169 Hunter St Newcastle DA2017/00701.02 - PPSHCC-31 Changes to Block one within Stage One

Responses to questions from the Acting Chair about Newcastle East Applications:

- Modification to the Concept Application DA-2017/00701.02: PPSHCC-31
- DA-DA2019/01150: Hotel Building: PPSHCC-27

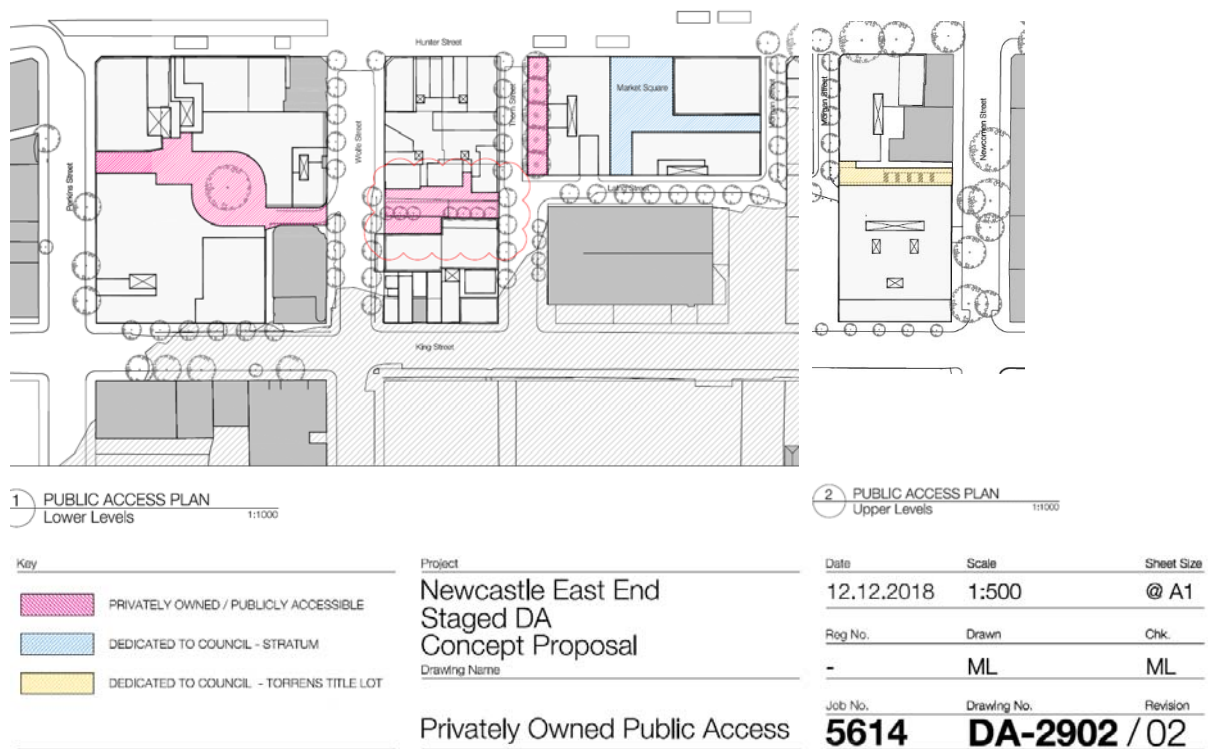
- *For context, width and nature of other laneway connections across the site so we can put the amendments in a wider context?*

The Four Block Concept Plans (current, as-approved) has several laneway connections as shown coloured below. NB. The plans include two scales (?) and there are no dimensions. However, it is noted that the laneway widths within Blocks 1 and 2 reflect the as-approved physical works (Stage 1 and 2 DAs).

A 'zoomed in' excerpt of Figure 21 from the report is provided below to make it clearer.

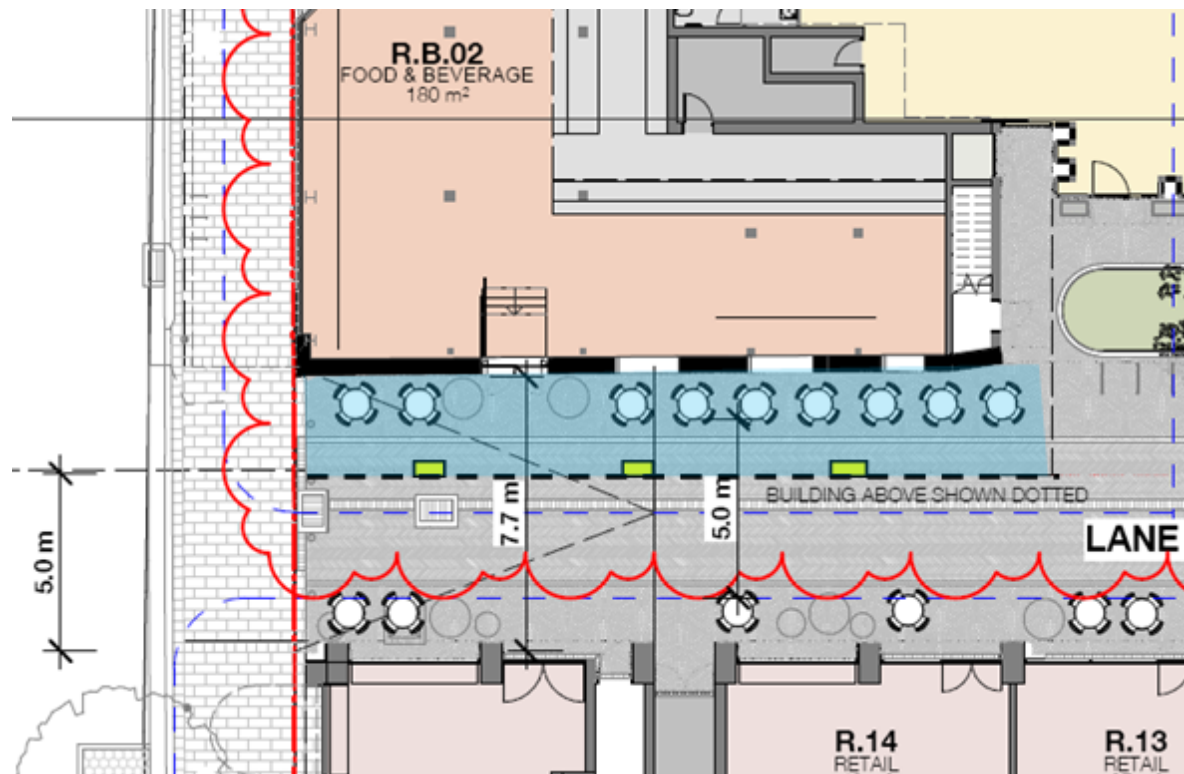
- *confirm width at ground level for laneway is 7.7m but with building above leaving 5m of laneway open to the sky, with columns however sitting within the 5m width both at ground level and levels above? What is min width where columns are proposed? The assessment references 5m width to open air, but the plans to be approved notate the width as 4.5m – is that 0.5m difference due to the support columns? The assessment report references Figure 21 on page 31 in respect to this, please supply Figure 21?*

Yes, the laneway is 7.7m wide at ground level. The columns (three yellow rectangles) and building above (light blue shading) are located within this 7.7m wide lane. A five (5) metre clearance is provided on the southern side of this structure (see dimension at left of the Figure). I am not sure which "...plans to be approved notate the width as 4.5m"? Figure 21 is an excerpt of *SJB Architects Dwg P-A-0201 Rev 22* which is listed to be approved?

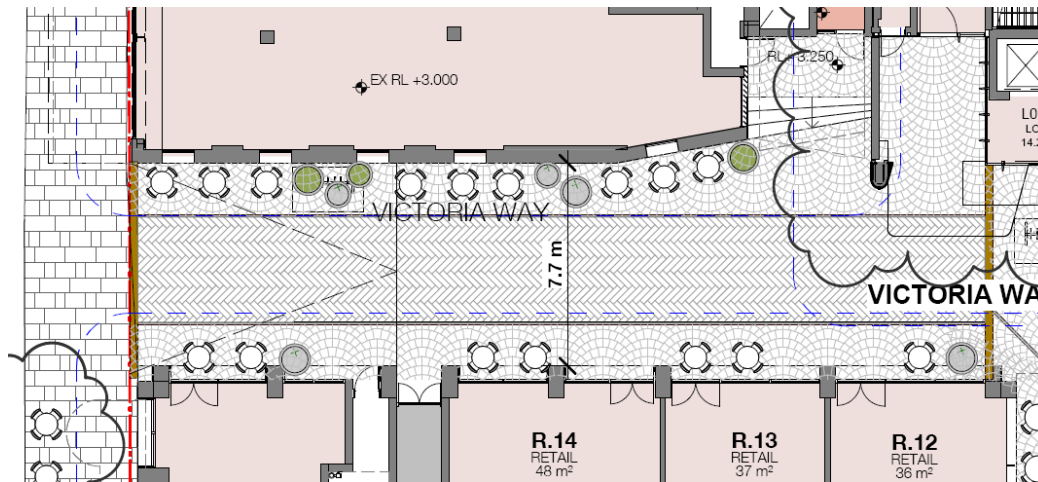
- *please confirm what the width reduction above ground represents compared to approved concept and also to approved Stage 1 consent, and how that reduction compares to a typical awning if floor space wasn't provided above?*

An excerpt from the approved Stage 1 plan (DA2017/700) is provided below, which shows a laneway width of 7.7m (at ground level) which also applied to all levels above. The approved concept plan reflected this width (*SJB Architects Dwg P-A-0201 Rev 16*, dated 9/11/2017).

NDCP 2012 includes controls relating to Awnings (6.01 A7 Awnings; and 7.10 Street Awnings and Balconies). Within the latter, Development Control 7.10.03 'Design requirements for awnings and balconies A. Dimensions' states: "1. *Depth of street awnings from the facade of buildings are **at least 2,000mm** or shall extend to within 600mm of the kerb in the case of footway formations less than 1,400mm.*"

If an awning was provided to this, it would be required to be a minimum width of 2 metres, which would leave an unobstructed width of 5.5m remaining.
